**APPLICATION FOR PERMISSION  
UNDER SECTION 16 OF  
THE TOWN PLANNING ORDINANCE  
(CAP.131)**

For Official Use Only 請勿填寫此欄	Application No. 申請編號	A/YL-LFS/420
	Date Received 收到日期	31 DEC 2021

(a) Proposed use(s)/development 擬議用途/發展	Proposed Temporary Shop & Services (Shop for Selling Hardware Accessories) for a Period of 3 Years  (Please illustrate the details of the proposal on a layout plan) (請用平面圖說明擬議詳情)

**Proposed Temporary Shop & Services (Shop for Selling Hardware Accessories) for a Period of 3 Years  
at  
Lots 1673 (Part), 1675 (Part), 1676 (Part), 1677 (Part) & 1678 (Part) in  
D.D. 129 & Adjoining Government Land, Lau Fau Shan, Yuen Long, N.T.**

### **PROPOSED LAYOUT PLAN**

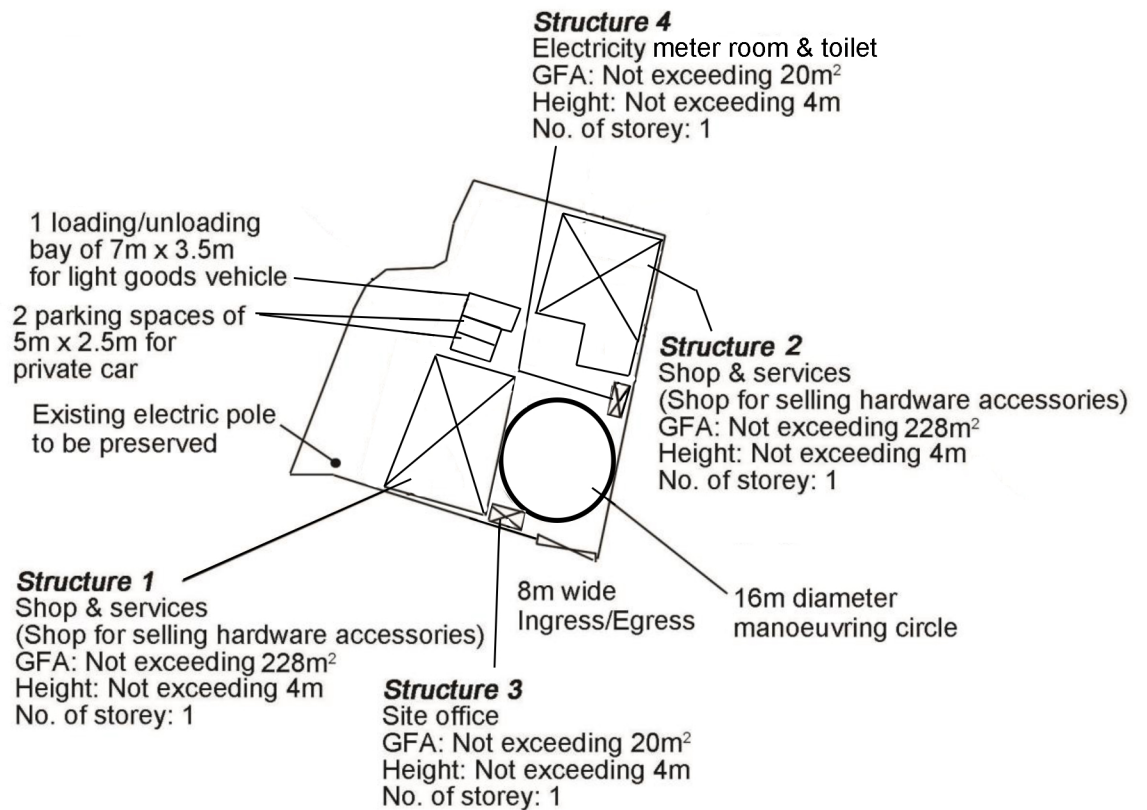
In order to address the comments of GEO, please see the response to comments and the updated geotechnical planning review report (GPRR) in the attachment. To make both the structure 1 and structure 2 at least seven meter away from the existing slope, the proposed layout plan has been updated as shown in Appendix E of the GPRR.
